# UNITED STATES PATENT AND TRADEMARK OFFICE

APPLICATION NO.	FILING DATE	FIRST NAMED INVENTOR	ATTORNEY DOCKET NO.	CONFIRMATION NO.
10/751,125	01/03/2004	Linggawati Tanamal	4001-0007 (ZM0515)	1756

<b>Office Action Summary</b>	<b>Applicati n N .</b>	<b>Applicant(s)</b>	
	10/751,125	TANAMAL ET AL.	
	<b>Examiner</b>	<b>Art Unit</b>	
	David Comstock	3732

## DETAILED ACTION

Figure A

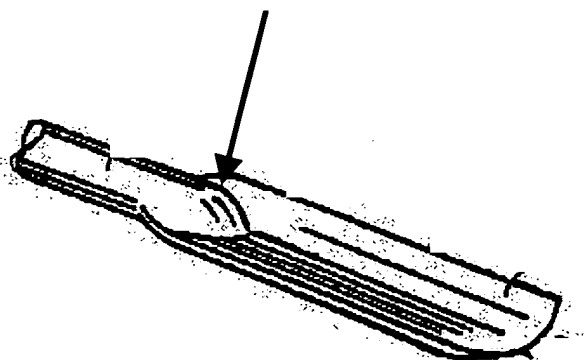
Wilhelmy, as modified, discloses the claimed invention except for the protuberance on the surface. Urbahns et al. disclose an osteotome 10 comprising a protrusion centered at the end of the surface to provide additional strength and rigidity to the device (see Figure A, below). It would have been obvious to provide a centered protrusion on the osteotome of Wilhelmy, as modified, in view of Urbahns et al., in order to provide additional strength to the surfaces and increase the rigidity of the device.

Protrusion reinforcing the blade

the device of Wilhelmy are sharp does not show that the proximal ends cannot be reinforced for more strength and reliability. Furthermore, as shown by Urbans et al., the protrusion would be on the top, i.e. the outside, of the device of Wilhelmy et al. Therefore, the protrusion would be at the opposite end from the cutting edge and on the outside or top of the device, and not within the bone plug region.
